City of Arnold, Missouri

Subject: RE: City Of Arnold Muddy Creek Drainage Project Draft Report

Muddy Creek Drainage Project

June 2016
DRAFT

Figure4: Blue Line – FEMA approved 100yr floodplain. Red Line – Alternative 1, 100yr floodplain.

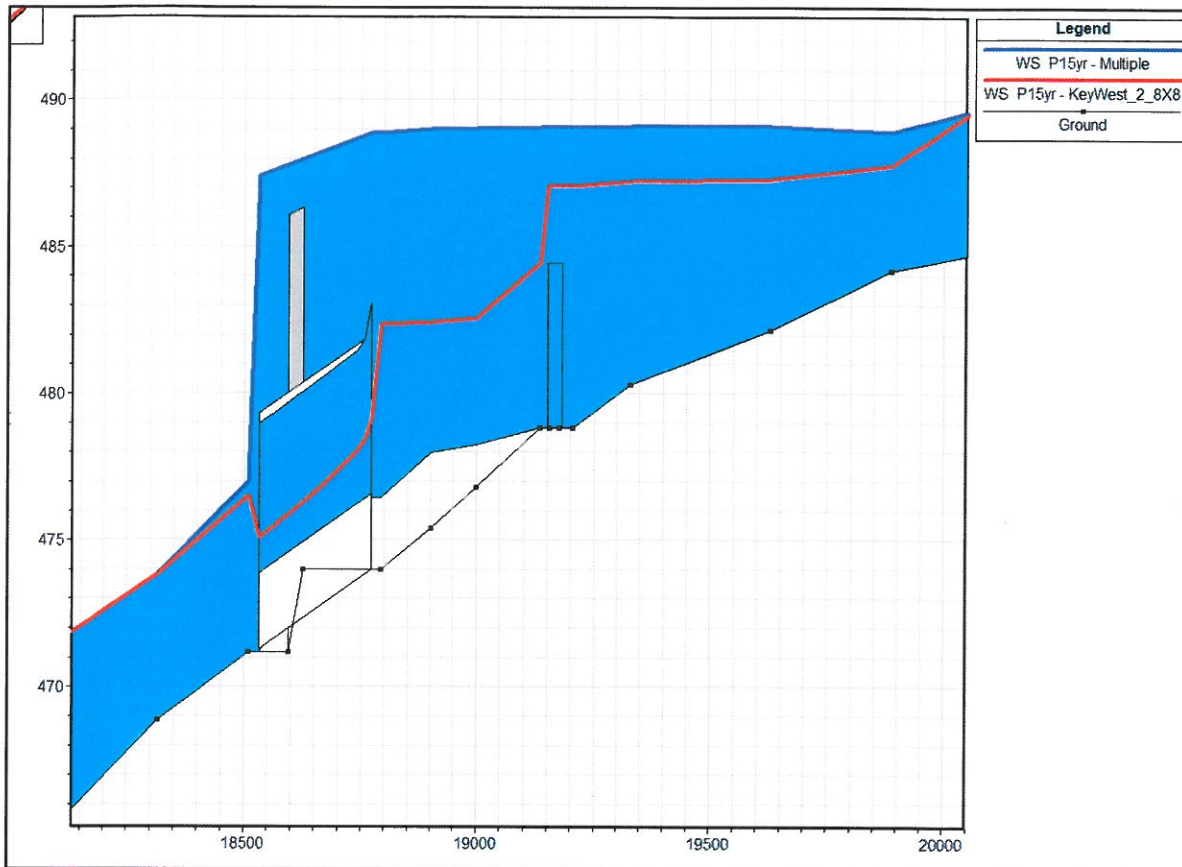
4. Alternative 1, Figure 4 shows significant reduction in the 100 year flood plain limits. Alternative 2, Figure 6 shows an even further reduction in the 100 year flood plain limits. Both figures appear to show a slight reduction in floodplain limits downstream of the Key West Drive location. Could another exhibit be prepared to show the blue and red lines all the way down to the outer road for comparison review? Please advise.
